## **RESPONSE TO REQUEST FOR INFORMATION - SCEGGS DARLINGHURST SSD-8893**

This letter has been prepared in response to the requests for additional information, dated 12 December 2019 and 13 January 2020, as it relates to the State Significant Development Application (**SSDA**) at SCEGGS Darlinghurst (**SSD-8893**).

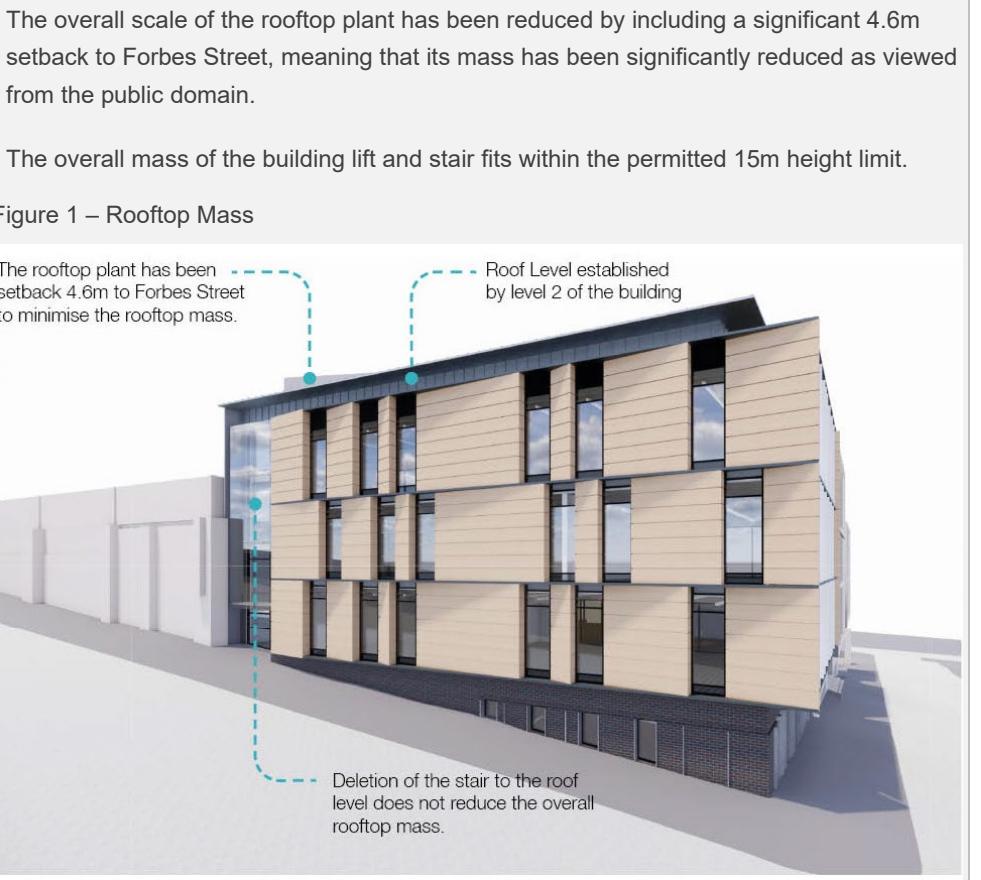
Request	Response
<p>4. Confirm how the alcove created by the Wilkinson House recessed stair core on the Forbes Street frontage would be treated to prevent anti-social behaviour / litter and the like.</p>	<p><i>Source: TKD Architects</i></p> <p>The stair core has been recessed from the Forbes Street Boundary in order to:</p> <ol style="list-style-type: none"> <li>1) Create a visual separation between the building and the adjacent Centenary Sports Hall and modulate the high-quality façade; and</li> <li>2) Allow for the fire egress door to be discreetly located on the side wall of the alcove, which avoids having a blank fire door facing the street and allows for the egress door to not open out over the property boundary (which it is not permitted to do by BCA).</li> </ol> <p>The external alcove created by the Wilkinson House recessed stair core is fully visible from within the building by a fully glazed facade, providing natural surveillance and security of this area (<b>Figure 2</b>). The alcove will also be lit at night-time so that there are no dark or shaded areas to hide within.</p> <p>The school take pride in maintaining their buildings and keeping the campus clean and litter would be cleaned away as part of the school's daily maintenance and cleaning regime.</p> <p>The alcove is similar to the alcove located at the entry to the Joan Freeman Building on St Peter's Street, which similarly has good natural surveillance and lighting. The school have had no issues here with anti-social behaviour or litter.</p>

Request	Response
<p>5. Provide justification for not including a green roof on the roof and/or roof plant enclosure of Wilkinson House.</p>	<p>Figure 2 – Wilkinson House Ground Level</p>  <p>The external alcove created by the Wilkinson House recessed stair core is fully visible from within the building by a fully glazed facade, providing natural surveillance and security of this area.</p> <p>The fire egress door has been discreetly located on the side wall of the alcove, which avoids having a blank fire door facing the street and allows for the egress door to not open out over the property boundary (which it is not permitted to do).</p> <p>The alcove will be fully lit at night time so that there are no dark or shaded areas to hide in.</p> <p style="text-align: center;">F O R B E S   S T R E E T</p> <p>Source: TKD Architects</p> <p>A roof plant enclosure has been provided at the roof level and is shown on Architectural Drawing AR.DA.2015. The roof plant takes up approximately half of the roof area. The majority of the remaining roof area has been used to accommodate PV panels meeting the environmental initiatives of the project (Figure 3).</p>

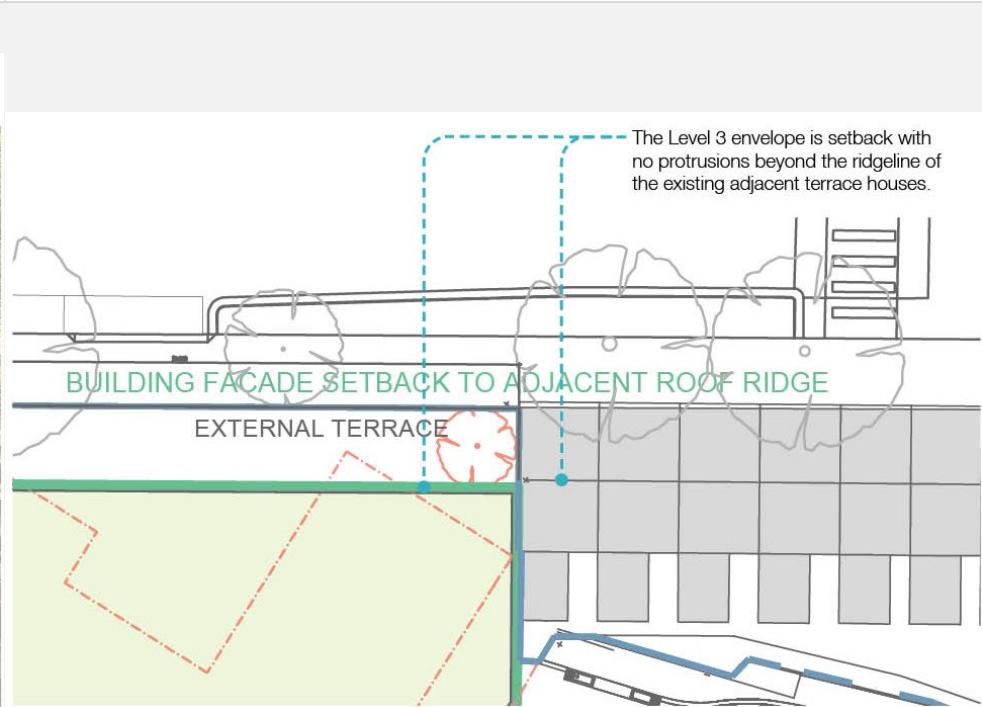
Request	Response
<p>16. For reference:</p> <ul style="list-style-type: none"> <li>a) update (to include RtS changes) and provide a copy of the 'landscaping/tree' image that was located at page 13 of the EIS Architectural Design Report.</li> <li>b) provide an 'as proposed' car parking/access image, based on the image that was located at page 15 of the EIS Architectural Design Report.</li> <li>c) provide a photograph of the Old Gym Building.</li> </ul>	<p>Architectural plan diagrams from page 13 and 15 of the EIS Architectural Design Report have been updated as requested to show the RtS proposal, refer <b>Attachment B</b>.</p> <p>A photograph of the existing Old Gym Building is provided below (<b>Figure 5</b>). This view is taken from the Main Lawn looking south towards the Old Gymnasium Building, which has been substantially modified externally with large concrete walkways, concrete stair and a brick stairwell.</p> <p>Figure 5 – Old Gymnasium Building</p>
